## ORIGINATION FORM

### Proposed Revisions to a Standard Plans Index (Please provide all information — Incomplete forms will be returned)

Index Number: 665-001  
Sheet Number (s): 1  
Index Title: Pedestrian Detector Assembly Installation  
Details

LAST REVISION 11/01/19	DESCRIPTION: 11/01/20	FDOT	FY 2020-21 STANDARD PLANS	PEDESTRIAN DETECTOR ASSEMBLY INSTALLATION DETAILS	INDEX 665-001	SHEET 1 of 1
---------------------------	--------------------------	------	------------------------------	--	------------------	-----------------

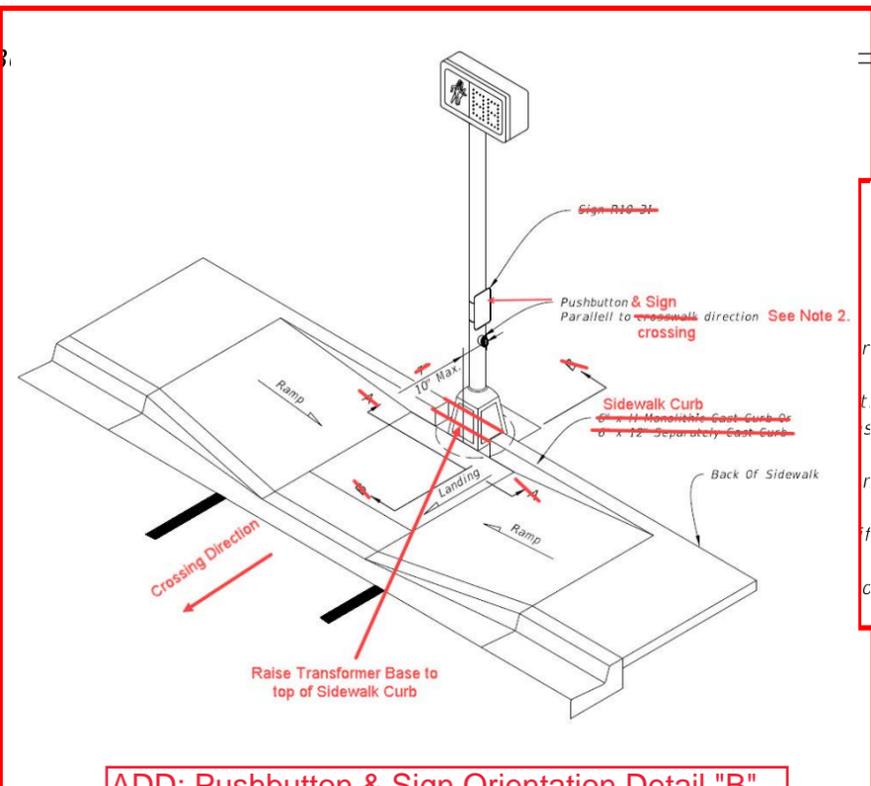
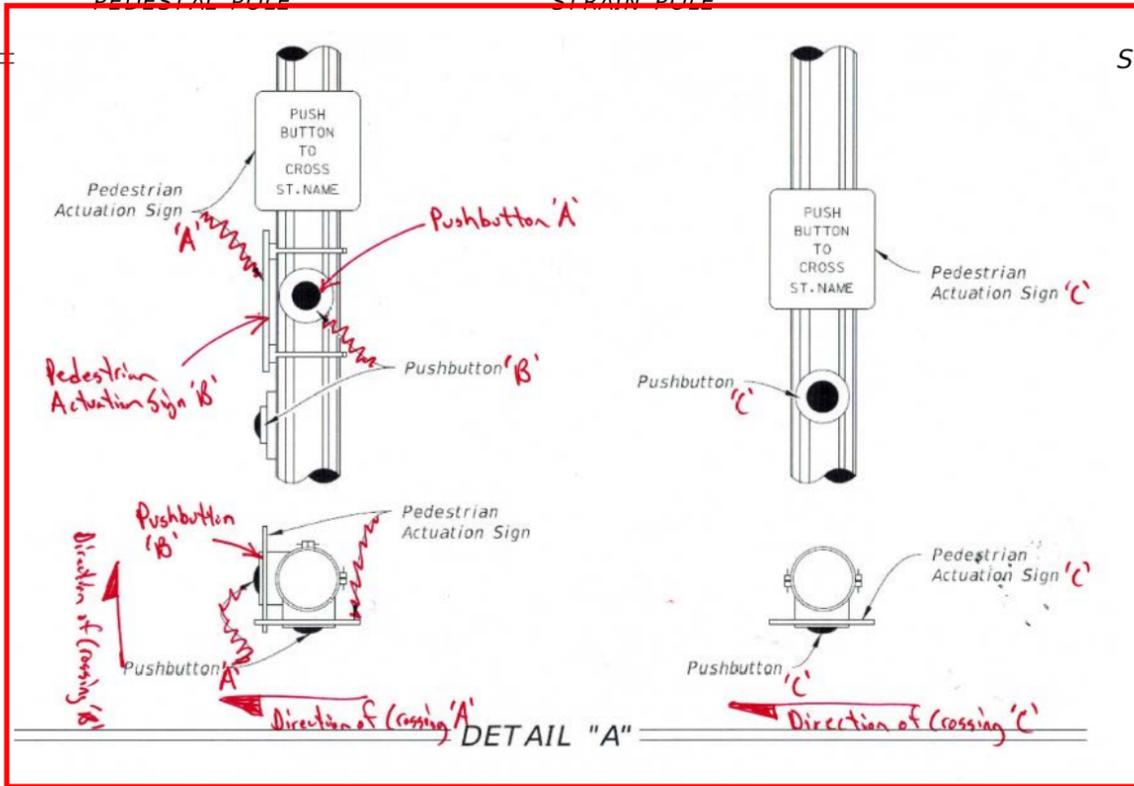
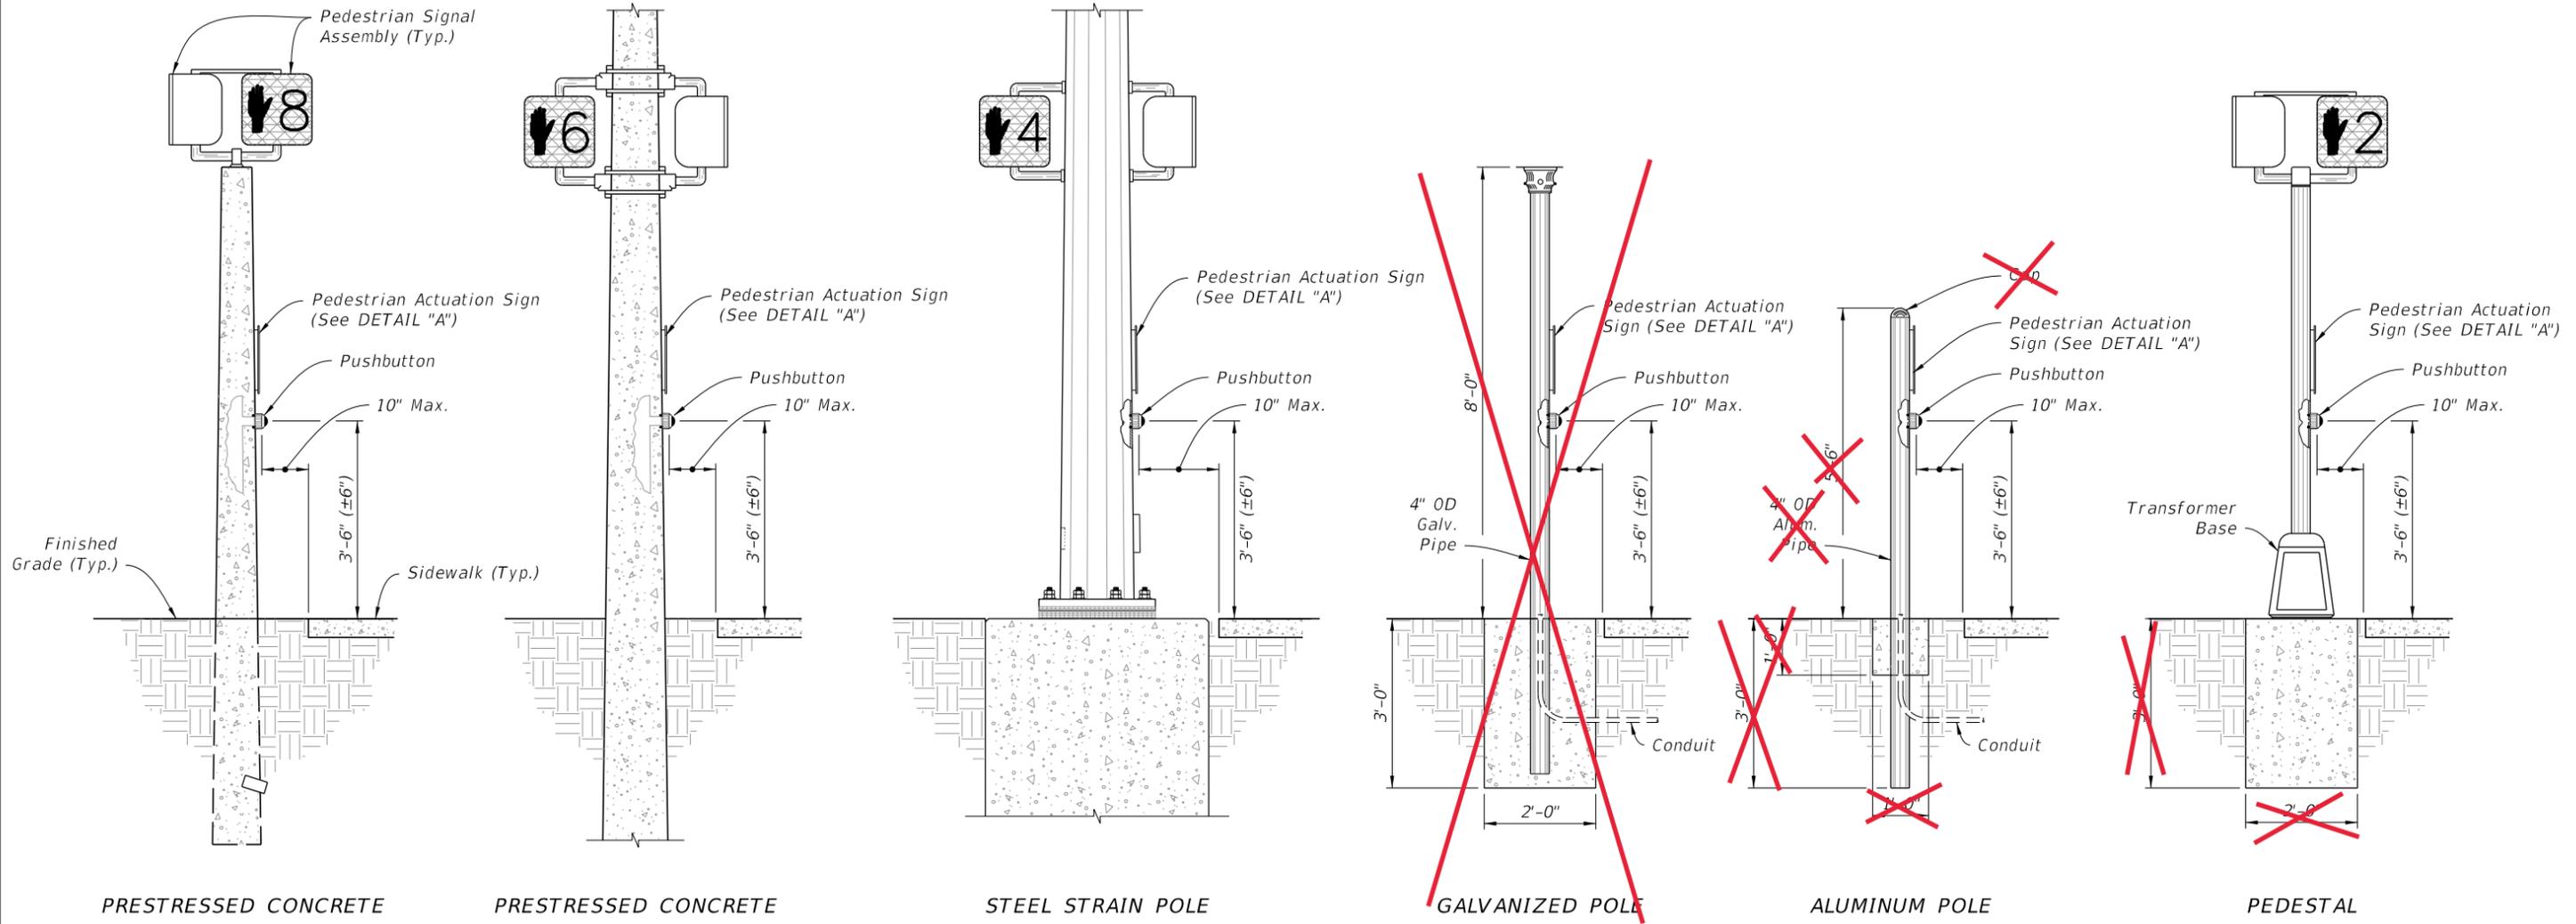
Deleted information specific to the Aluminum Pole and Pedestal supports. These details will be included in a New Standard Plans, Index 646-001. A Pushbutton Orientation (New Detail "B") has been added to clarify Note 2. Added further clarification of pushbutton and sign orientation to Detail "A". Deleted "Galvanized Pole" option, as it is not covered by Standard Specifications for Pay Items.

- NOTES:**
1. Mount Signs above the detectors. See Index 700-102 for sign details.
  2. Install Pushbuttons and Pedestrian Actuation Signs with faces parallel to the crossing direction, ~~or as shown in the Plans. See Detail "B".~~
  3. Mount pushbuttons and Signs in accordance with Specification 665.
  4. ~~Install all grounding per Specification 620.~~
  5. Pushbutton mounting height shown ~~above~~ is taken at the center of the actuation switch.
  6. For Pedestrian Control Signal see Index 653-001
  7. For Aluminum Pole and Pedestal supports see Index 646-001

ADD: Pushbutton & Sign Orientation Detail "B"

ALUMINUM POLE

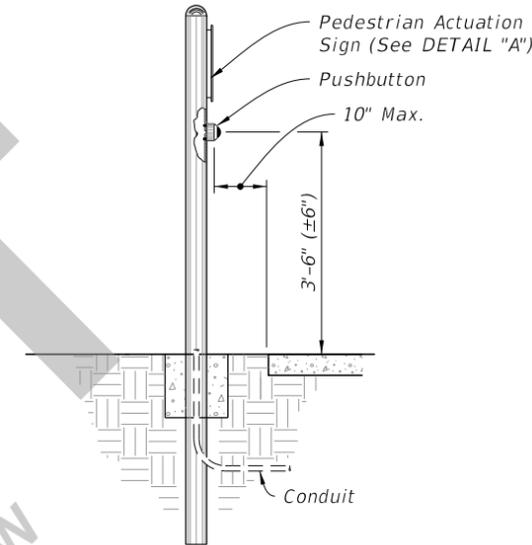
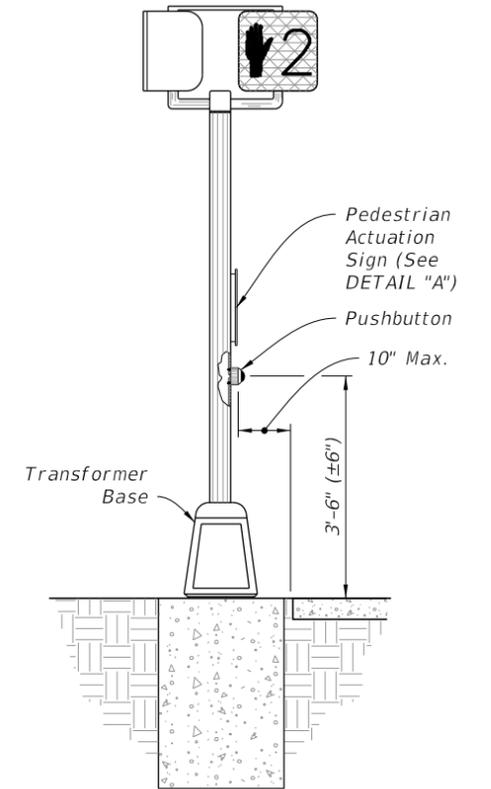
There has been confusion about the foundation requirements and payment for Aluminum Pole and Pedestal supports for pedestrian signal and detectors. Relocating this information to a NEW Index 646 will clarify the intent, as installation and payment information is covered by Specification 646. See Also: Revision to Index 653-001.

1. Mount Signs above the detectors. See Index 700-102 for sign details.
2. Install Pushbuttons and Pedestrian Actuation Signs with faces parallel to the crossing direction, see DETAIL "B".
3. Mount pushbuttons and Signs in accordance with Specification 665.
4. Pushbutton mounting height shown is taken at the center of the actuation switch.
5. for pedestrian control signal see index 653-001.
6. For Aluminum Pole and Pedestal supports see Index 646-001.
